# UNITED STATES PATENT AND TRADEMARK OFFICE

APPLICATION NO.	FILING DATE	FIRST NAMED INVENTOR	ATTORNEY DOCKET NO.	CONFIRMATION NO.
10/810,142	03/26/2004	Ephraim Jeff Gutmark	139141	8853

<b>Office Action Summary</b>	Application No.	Applicant(s)	
	10/810,142	GUTMARK ET AL.	
	Examiner	Art Unit	
	Ted Kim	3746

METHODS AND APPARATUS FOR OPERATING GAS TURBINE ENGINES  
 INVENTOR: EPHRAIM J. GUTMARK, et al.  
 DOCKET: 139141  
 ATTY: ROBERT B. REESER, III; PHONE: (314) 621-5070  
 REPLACEMENT SHEET

FIG. 3

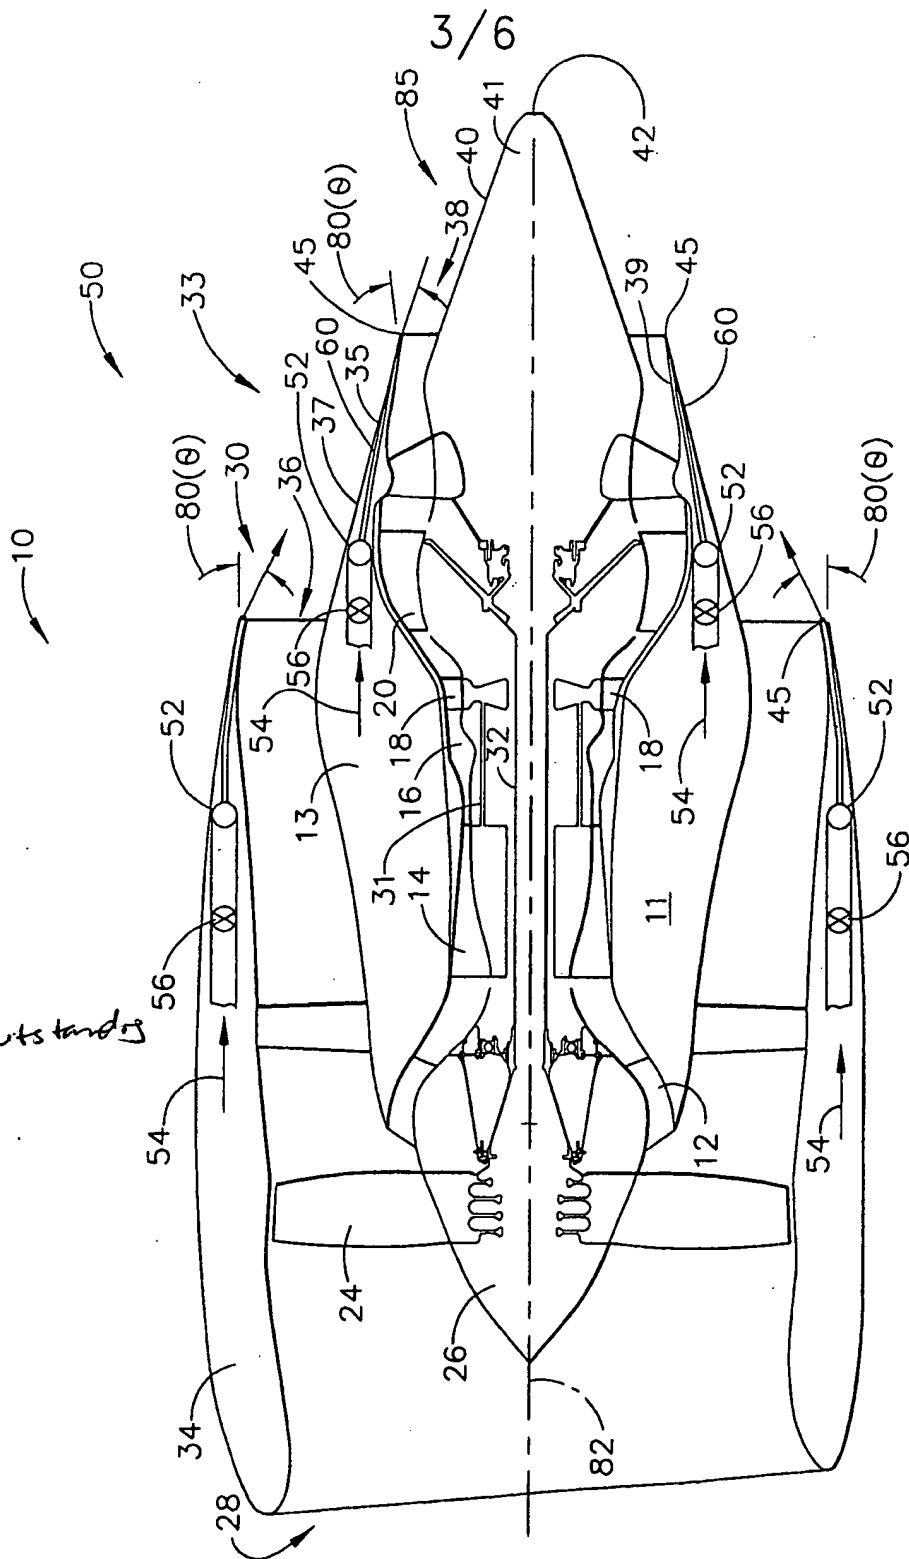
1. The drawings are objected to for failing to correspond with the specification. The following problems have been identified for Figs. 3 and 4:

For Figures 4, 6, the tubes 70 are not shown with **triangular chevrons** on the fan exhaust nozzle 30. The following paragraphs make it clear that the tubes are to be used on both sides of the chevrons but this is not properly illustrated for the fan nozzle 30. There are no chevrons illustrated for the fan nozzle 30, only for the core nozzle.

Entry  
 Approved.

Other  
 objections  
 remain outstanding
